# LACHLAN'S LINE LOT 110

## RESIDENTIAL APARTMENT BUILDING DEVELOPMENT APPLICATION - ALTERATIONS & ADDITIONS

5 HALIFAX STREET,  
MACQUARIE PARK

1 NORTH ELEVATION  
1 : 200

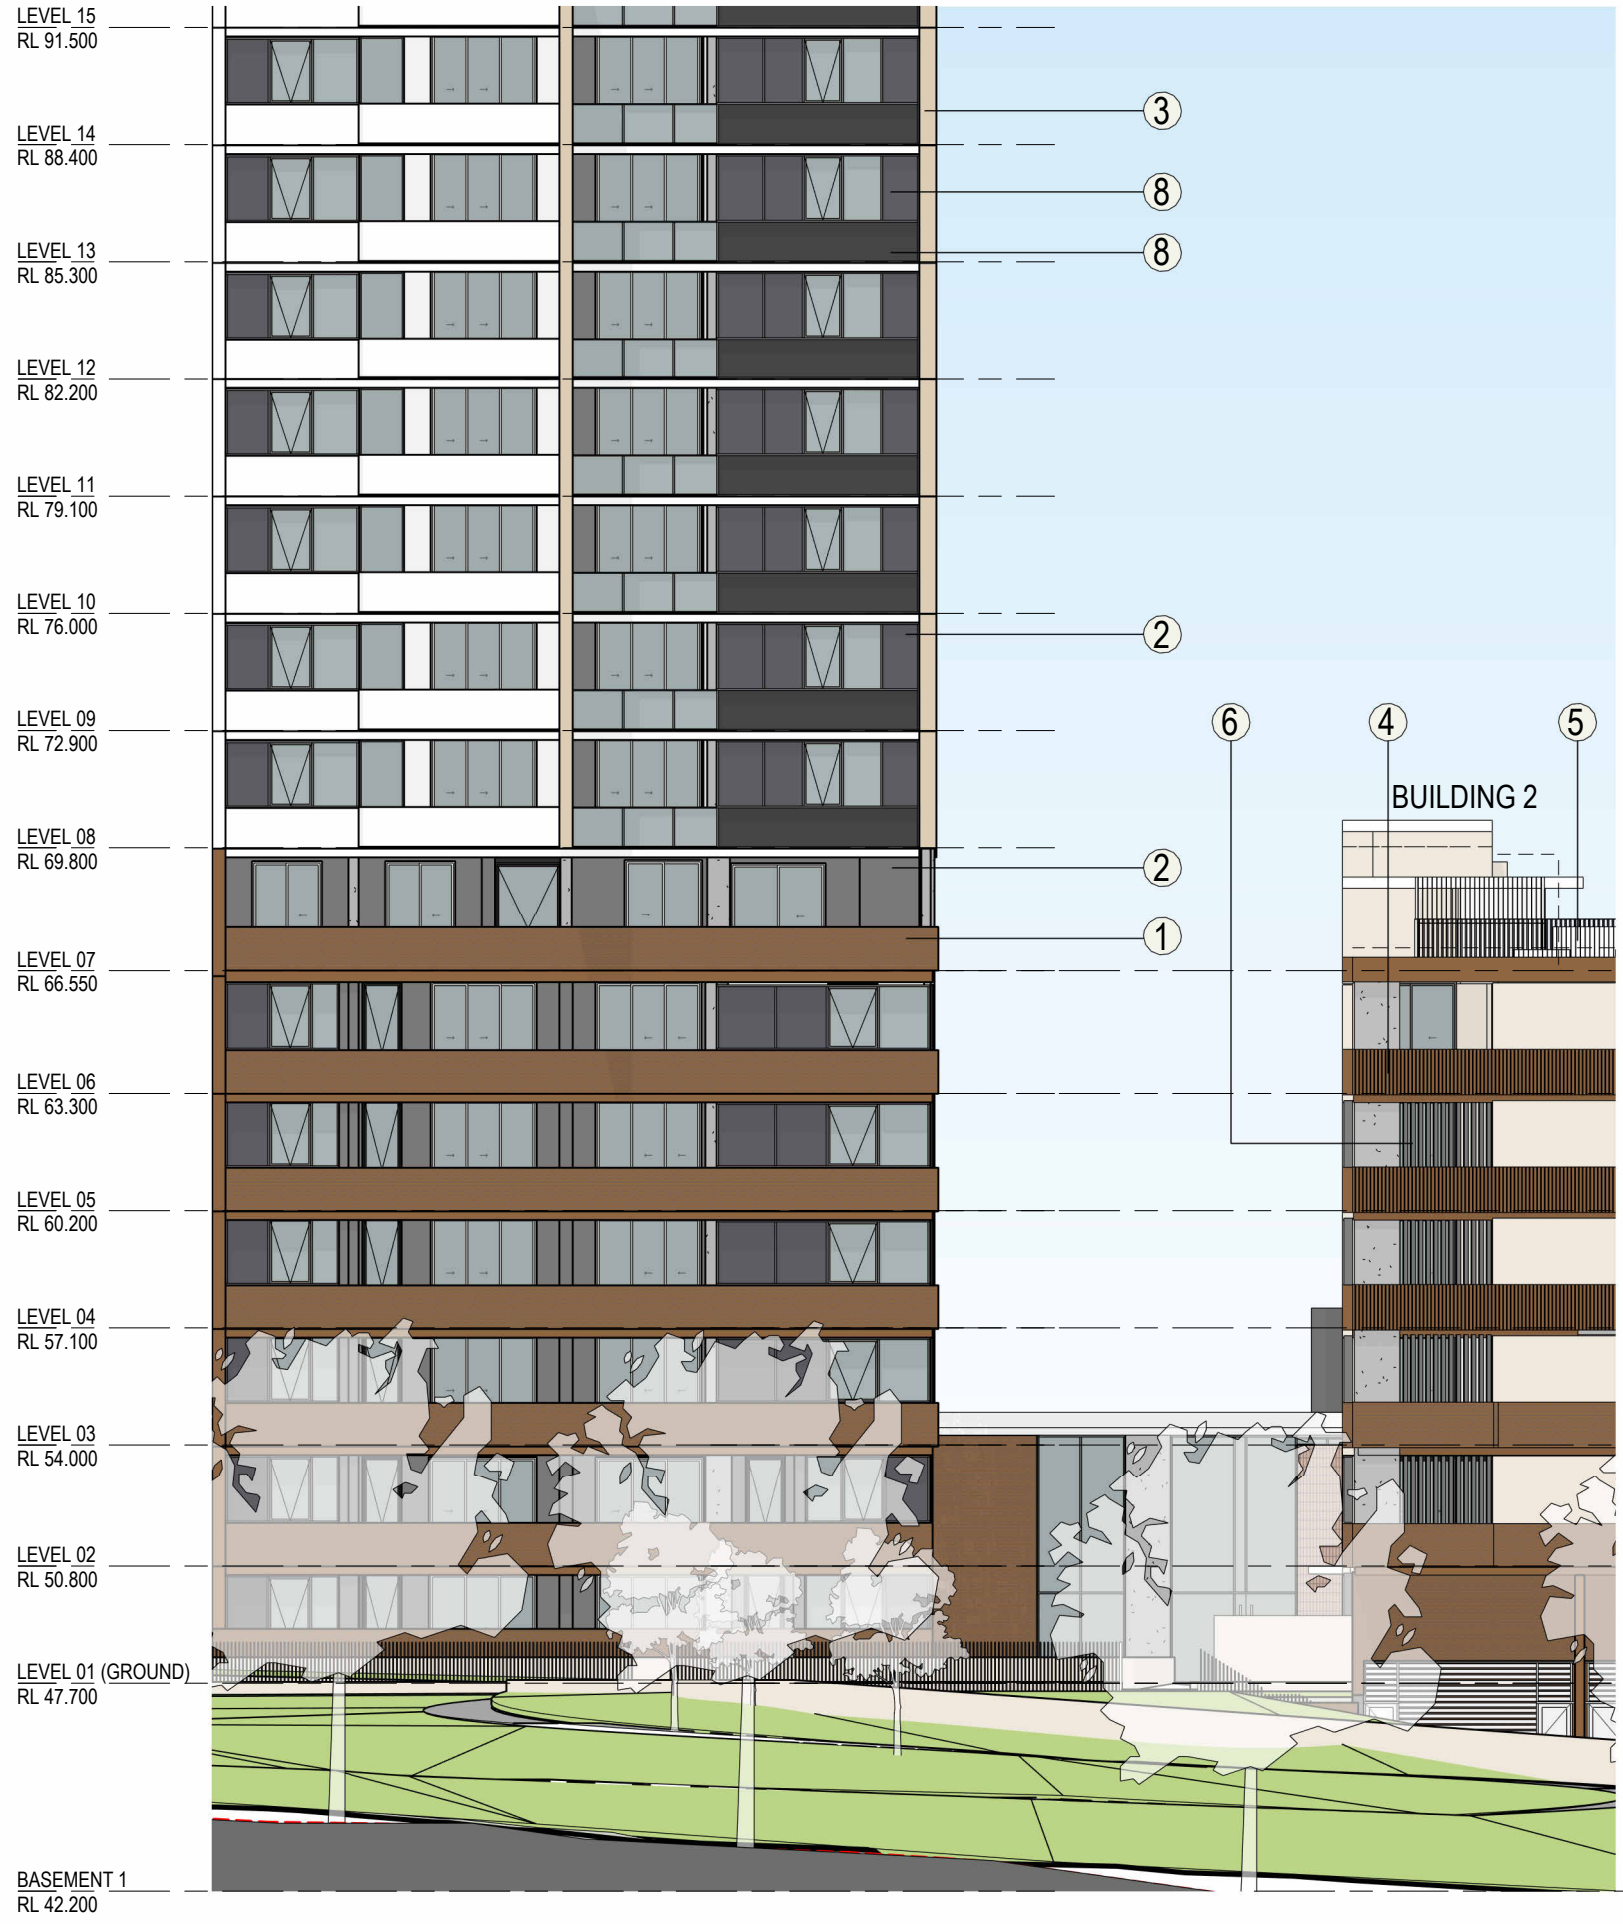
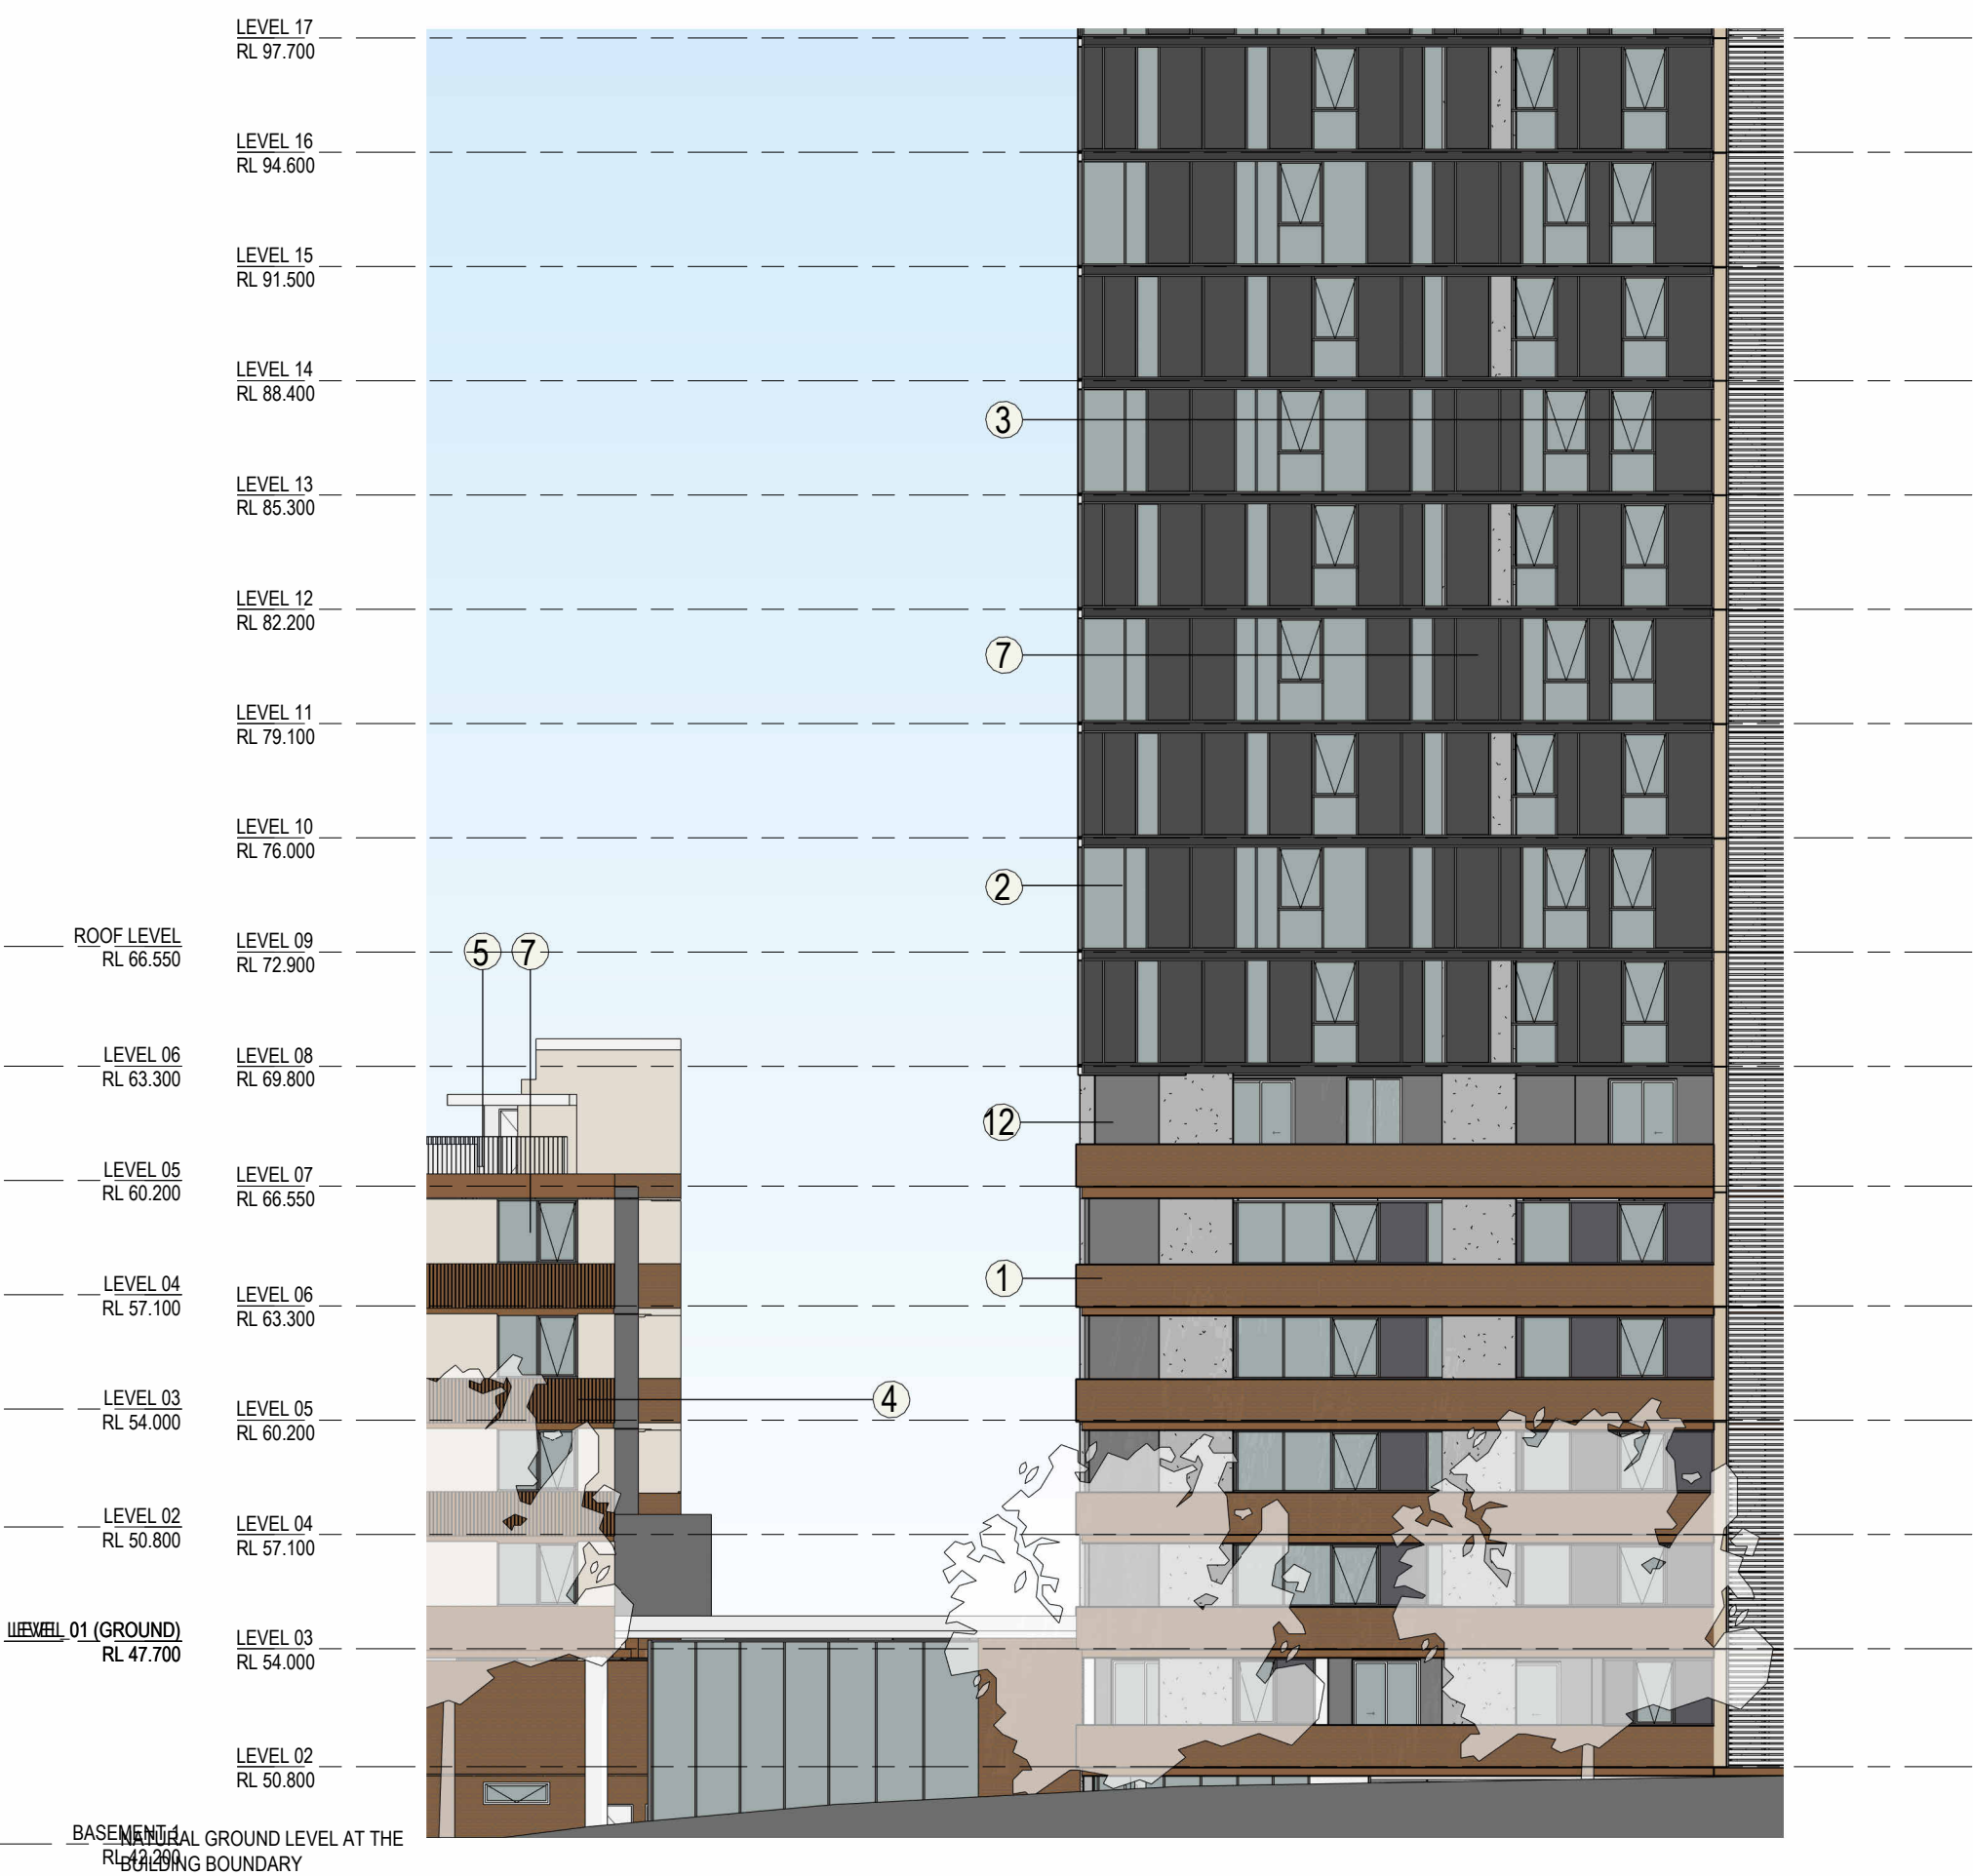
COLOURS ADDED; CODES REVISED

COLOURS ADDED
